# UNITED STATES PATENT AND TRADEMARK OFFICE

APPLICATION NO.	FILING DATE	FIRST NAMED INVENTOR	ATTORNEY DOCKET NO.	CONFIRMATION NO.
09/766,749	01/22/2001	Conal O'Neill		1254

# Office Action Summary

## ***Final Rejection***

FIG. 3

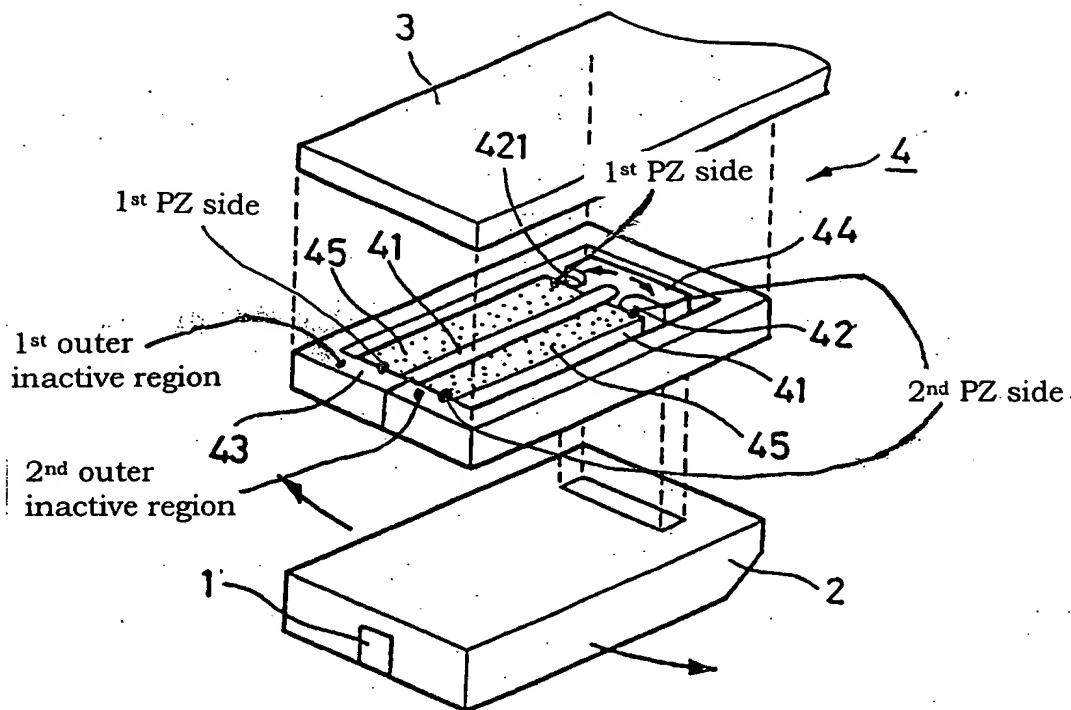
With regard to claims 1-3 and 8-10, Soeno et al shows a disc drive actuation system for precisely positioning a read/write head over a selected track of a rotatable disc (Figs. 18, 19 and 32), the system including: A) a flexure (means) 31 (Column 27, line 41), B) a slider (means) 2 (Column 13, line 44), C) a read/write head 1 firmly attached to the slider, D) a first drive unit (means) 5 (Fig. 32, column 1, line 55) for pivoting the flexure to position the read/write head (means) approximately over the selected track, which is a voice coil motor, E) a microactuator 4 (Figs. 18 and 3) including: 1) an inner inactive region 44, 2) a first outer inactive region (See attached Fig. 3 with added numerals in next page) a second outer inactive region (See attached Fig. 3), 4) a first piezoelectric section (left of 45) sandwiched between the first outer inactive region and the inner inactive region, 5) a second piezoelectric section (right of

45) sandwiched between the second outer inactive region and the inner inactive region, wherein the inner inactive region is firmly attached to the slider (means) and both of the outer inactive regions being firmly attached to the flexure (means) (Column 6, lines 35-37), 6) an inherent electrical circuit for energizing the first and the second piezoelectric sections to cause them to expand and contract in order to precisely position the read/write head (means) over the selected track (Column 34, lines 44-57), the circuit and the piezoelectric sections being configured such that the first piezoelectric section expands when the second piezoelectric section contracts and the first piezoelectric section contracts when the second piezoelectric section expands, which is shown in Fig. 3, wherein the above mentioned action causes the slider on 44 to rotate as shown in Fig. 3.

With regard to claims 23, 24, and 25; Soeno et al further shows the first piezoelectric section includes two first piezoelectric sides, wherein both of the first piezoelectric sides are opposite to each other (See attached Fig. 3), and wherein the second piezoelectric section includes two second piezoelectric sides (See attached Fig.

3), wherein both of the second piezoelectric sides are opposite to each other, wherein one of the two first piezoelectric sides is rigidly attached to the first outer inactive region and wherein the other of the two first piezoelectric sides is rigidly attached to the inner inactive region, and wherein one of the two second piezoelectric sides is rigidly attached to the second outer inactive region and wherein the other of the two second piezoelectric sides is rigidly attached to the inner inactive region.

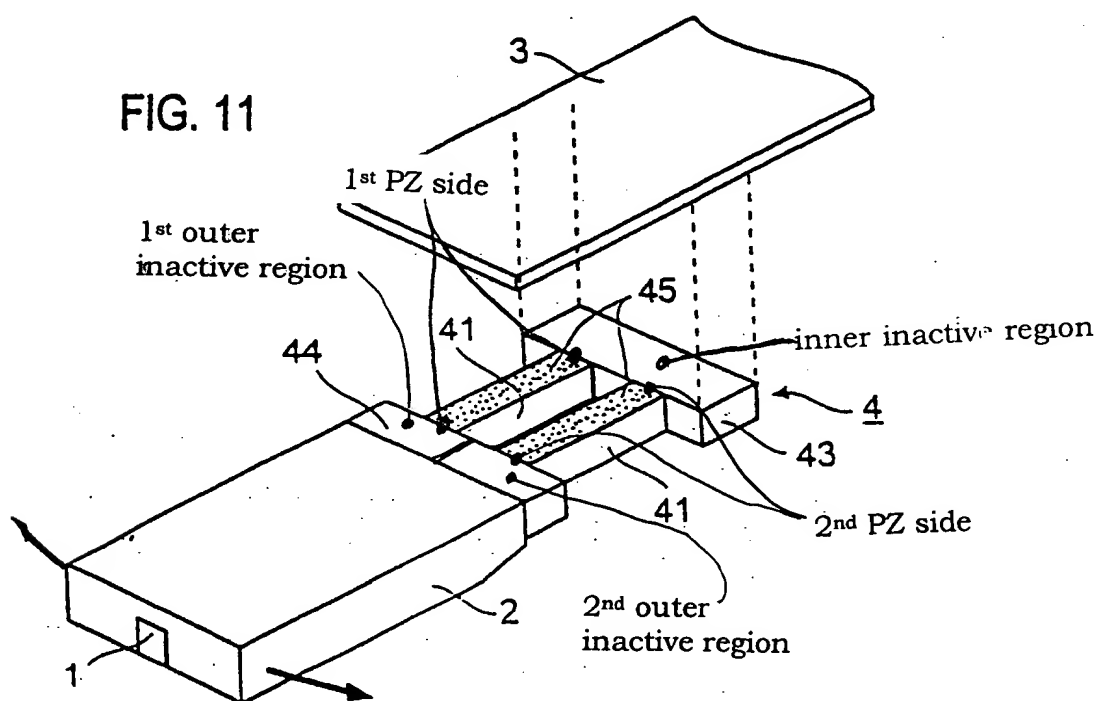
With regard to claims 4/1, 11/8, and 15; Soeno et al shows a disc drive actuation system for precisely positioning a read/write head over a selected track of a rotatable disc (Figs. 18, 19 and 32), the system including: A) a flexure (means) 31 (Column 27, line 41), B) a slider (means) 2 (Column 13, line 44), C) a read/write head 1 firmly attached to the slider, D) a first drive unit (means) 5 (Fig. 32, column 1, line 55) for pivoting the flexure to position the read/write head (means) approximately over the selected track, E) a microactuator 4 (Figs. 18 and 11) including: 1) an inner inactive region 43 (Fig. 11) a first outer inactive region (See attached Fig. 11 with added numerals in next page) a second outer inactive region (See attached Fig. 11),

4) a first piezoelectric section (left of 45) sandwiched between the first outer inactive region and the inner inactive region, 5) a second piezoelectric section (right of 45) sandwiched between the second outer inactive region and the inner inactive region, wherein the inner inactive region is firmly attached to the flexure (means) and both of

the outer inactive regions being firmly attached to the slider (means), 6) an inherent electrical circuit for energizing the first and the second piezoelectric sections to cause them to expand and contract in order to precisely position the read/write head (means) over the selected track (Column 34,, lines 44-57), the circuit and the piezoelectric sections being configured such that the first piezoelectric section expands when the second piezoelectric section contracts and the first piezoelectric section contracts when the second piezoelectric section expands, which is shown in Fig. 11, wherein the above mentioned action causes the slider on 44 to rotate as shown in Fig. 11.

With regard to claim 15, Soeno et al further shows the slide is independently supported by the microactuator (Fig. 11).
